HEARING DATE: 11/17/2022
 TO: Planning & Zoning Commission
 FROM: Joseph Dodson, Associate Planner
 208-884-5533
 SUBJECT: H-2022-0072
 Centrepoint Apartments CUP
 LOCATION: Located at 3100 N. Centrepoint Way, near the southwest corner of N. Eagle and E. Ustick Roads, in the NE 1/4 of the NE 1/5 of Section 5, Township 3N, Range 1E.

Conditional Use Permit request for 213 multi-family residential units on approximately 10 acres in the C-G zoning district, by MGM Meridian LLC.

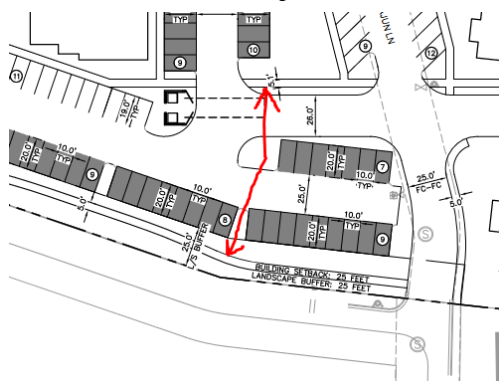
Staff supports the proposed sidewalk and micro-path network except for the lack of connectivity to the southern micro-path near the southeast corner of the central area (see snip). There is no

internal connection to this micro-path and it also does not connect to any sidewalk along the shared drive aisle. So, there is minimal opportunity to access this desirable micro-pathway from within the site.

Therefore, per the red markup to the left, Staff is recommending a loss of one parking space left of the planter island and the addition of more 5-foot wide sidewalk/pathway in the general location depicted to increase the pedestrian connectivity and further activate the micro-path along the south boundary.

- c. Add a pedestrian connection from the micro-pathway along the south boundary north to an existing sidewalk near the southeast corner of the site, generally consistent with the exhibit within the Staff Analysis section above (Section V.B).
